**Waterdown/Aldershot Transportation Master Plan: Phase 3**  
*Agency Comments Database*  
**January 2008 to May 2009**

This document includes all questions and responses by the agencies received from January 2008 to May 2009 for the Waterdown/Aldershot Transportation Master Plan – Phase 3. This list is in chronological order from the date in which the comment/question was received. This document was prepared by Lura Consulting, the neutral third-party consultation facilitator for this project.

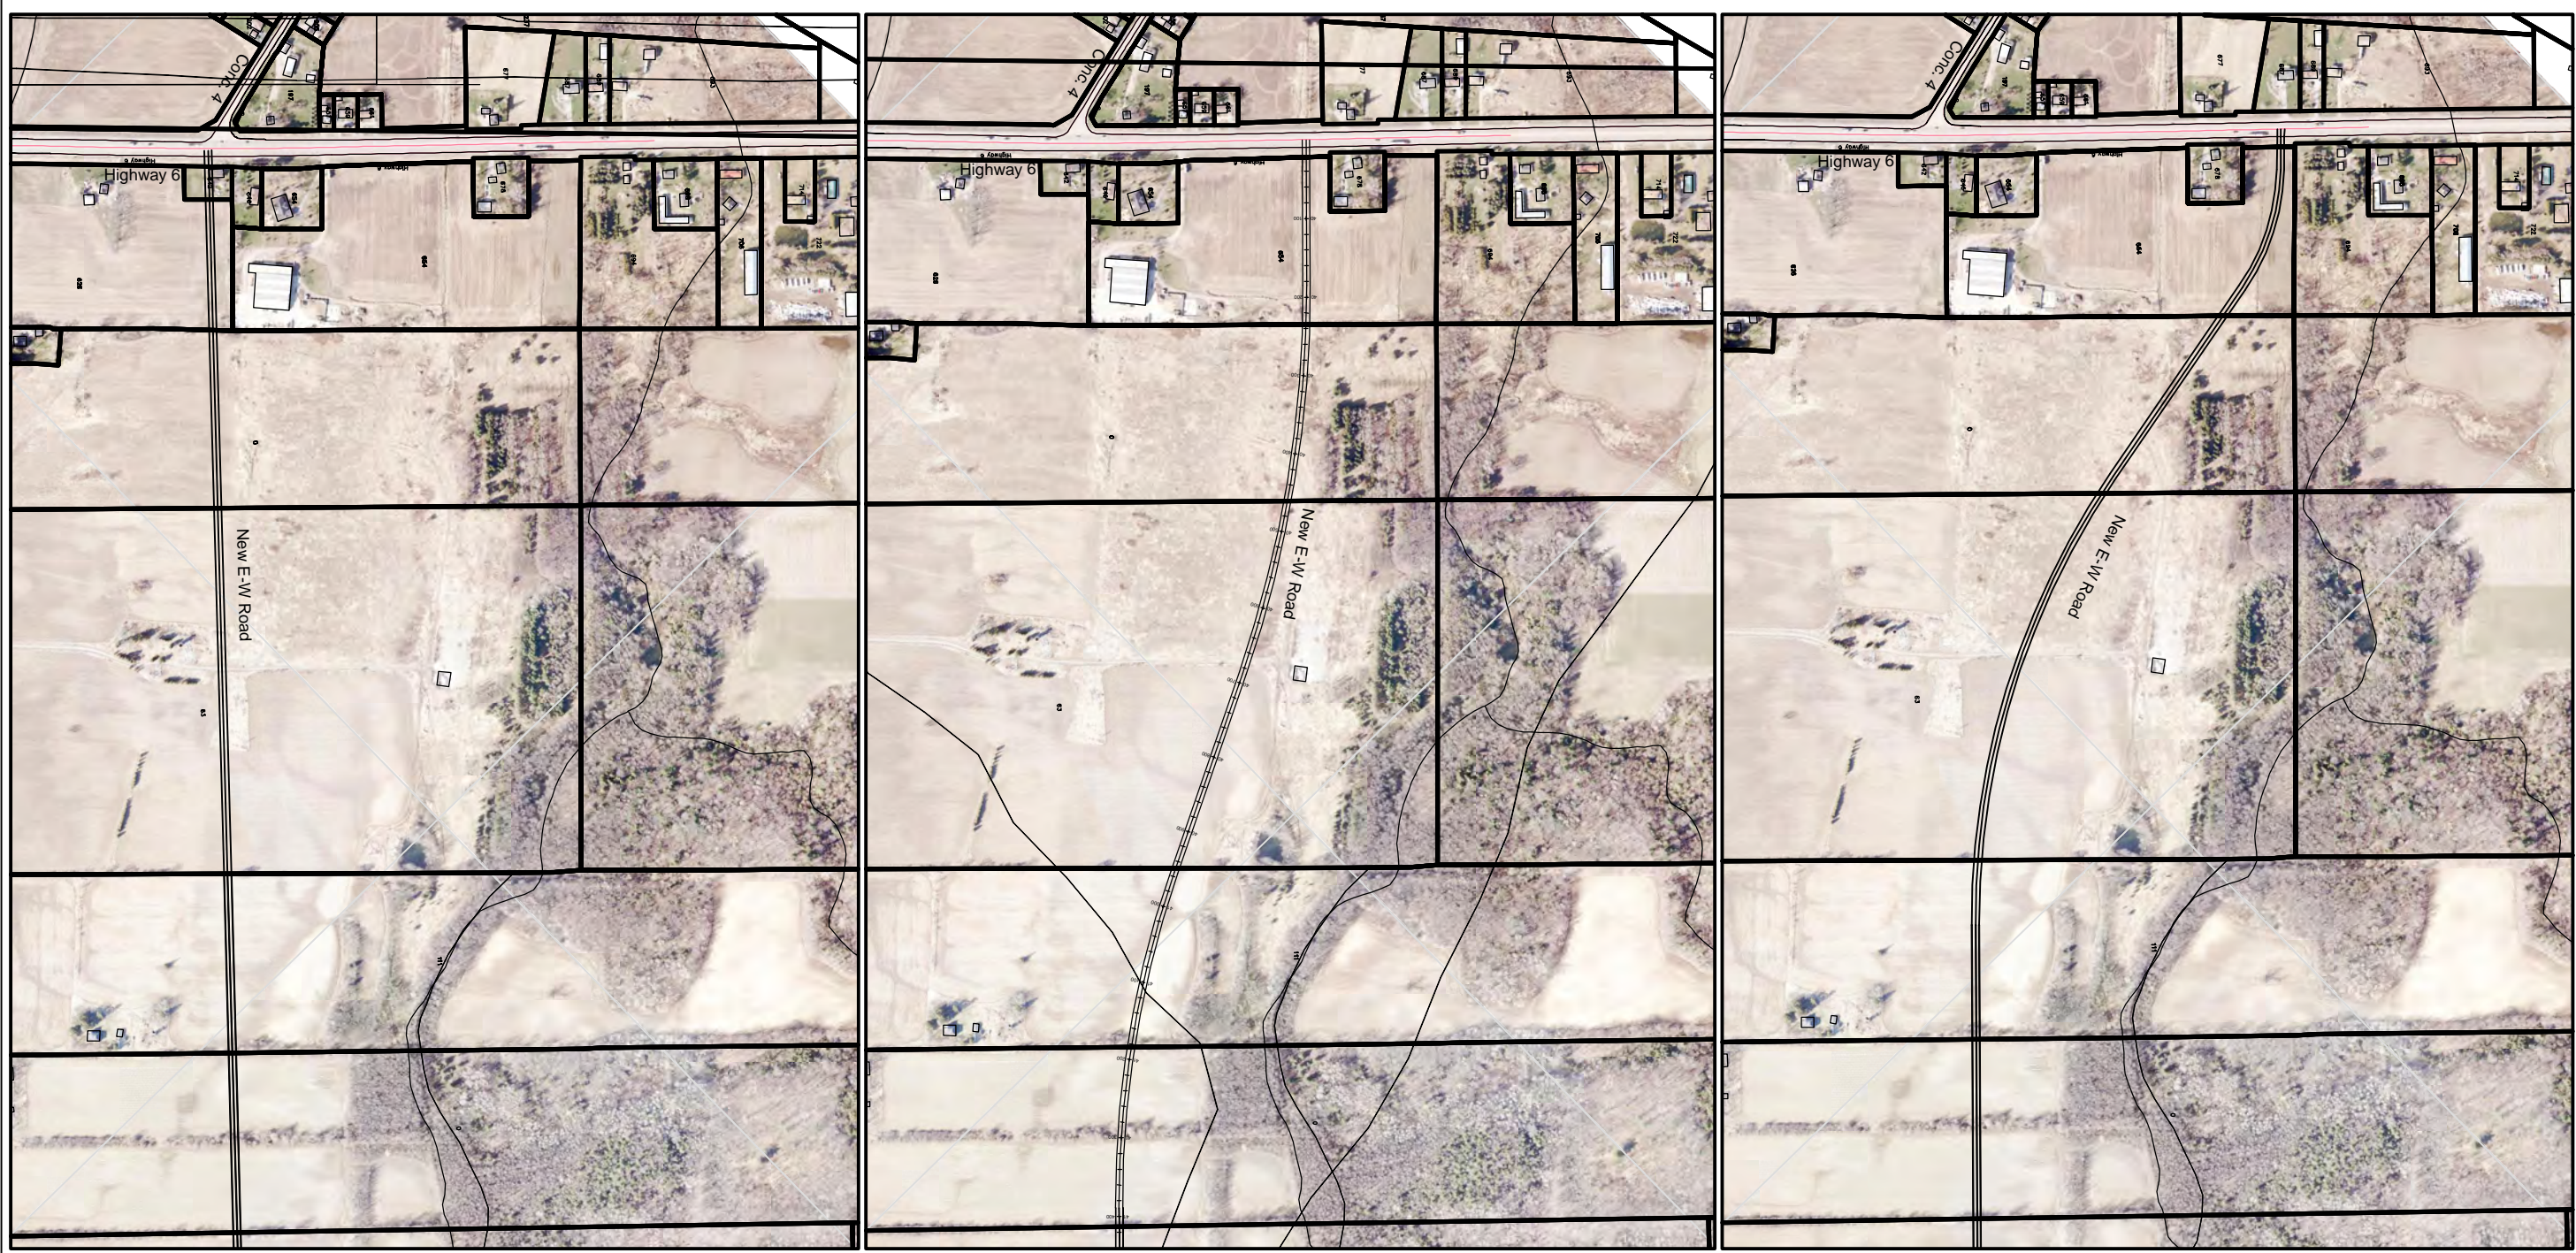
<p><b>ID# 237</b>                  Anne Gibbs (Diocese                  of Hamilton)                  Oct 23, 2008                  Telephone</p>	<p>I would like to know how the proposed east-west road will affect the                  Diocese of Hamilton. We have a property at X Centre Road, how                  will this road affect us? Where will the road intersect Centre Road                  and where will it come out?                  I would also like to request an enlarged and more detailed map of                  the area.</p>	<p>Waterdown-                  Aldershot                  Information</p>	<p>Waterdown-                  Aldershot                  Information                  Dec 3, 2008                  Email</p>	<p>Dear Ms. Gibbs,</p> <p>Thank you for your phone call dated October 23, 2008. We have                  obtained a response to your inquiry from the Project Team, and                  have provided it in blue below.</p> <hr/> <p><i>I would like to know how the proposed east-west road will affect                  the Diocese of Hamilton. We have a property at X Centre Road,                  how will this road affect us? Where will the road intersect Centre                  Road and where will it come out?                  I would also like to request an enlarged and more detailed map of                  the area.</i></p> <p><b>Response:</b> The proposed crossing location of Centre Road with                  the new east-west roadway is considerably south of your                  property. The proposed locations for the new intersection are                  approximately 160 metres north of the current Centre</p>

<p>Road/Northlawn Avenue intersection. The new road will cross Centre Road and continue east to connect with Parkside Drive. The air photo below shows the crossing location alternatives that were considered. The light blue alignment (second from the bottom) is currently the preferred crossing location.</p>
<p><b>ID# 269</b>                  Ontario Realty Corporation                  Nov 4, 2008                  Email</p>	<p>Please see attached letter.                  Thank you.                  Hoeun Heng                  Ontario Realty Corporation</p> <p><i>Attached letter, with map, reads:</i></p> <p>November 3, 2008                  To Whom It May Concern,  <b>RE: ORC Initial Comments on Notice of PIC Class EA, New east-west corridor and Waterdown Road corridor</b>                  Thank you for circulating Ontario Realty Corporation (ORC) on your Public Information Centre.                  The ORC is the strategic manager of the government's real property with a mandate of maintaining and optimizing value of the portfolio, while ensuring real estate decisions reflect public policy objectives of the government. Our preliminary review of your notice and supporting information indicates that ORC-managed property is directly in the study area. As a result, your proposal may have the potential to impact this property and/or the activities of tenants present on ORC-managed lands. Attached please find a map that identifies this property to assist you in identifying and avoiding potential impacts.</p> <p><b>Potential Negative Impacts to ORC Tenants and Lands</b>  <b>General Impacts</b>                  Negative environmental impacts associated with the project design and construction, such as the potential for dewatering, dust, noise and vibration impacts, and impacts to natural heritage features/habitat and functions, should be avoided and/or appropriately mitigated in accordance with applicable regulations best practices and MNR and MOE standards. Avoidance and</p>	<p>Waterdown-Aldershot Information</p>	<p>Waterdown-Aldershot Information                  Dec 4, 2008                  Email</p>	<p>Dear Ms. Myslicki,</p> <p>Thank you for your letter dated November 3, 2008. We have obtained a response to your inquiry from the Project Team, and have provided it in blue below.</p> <hr/> <p><b>Project Team Response:</b> Thank you for your letter and interest in the Waterdown Road Class Environmental Assessment. In reviewing the information you provided, it would appear that Waterdown Road crosses two power transmission line corridors that are under the mandate of the Ontario Realty Corporation (ORC). We have not identified any other lands to be required from the ORC. As it is proposed that Waterdown Road be widened from two to four lanes, there could be the need for lands contained within these power transmission corridors. We are in the process of confirming property needs along the entire length of roadway. Once this has been confirmed, we will contact you to advise of the land requirement and to discuss the process to facilitate this.</p> <hr/> <p>Kind regards,                  Patricia Halajski née Prokop on behalf of Sally Leppard,</p>
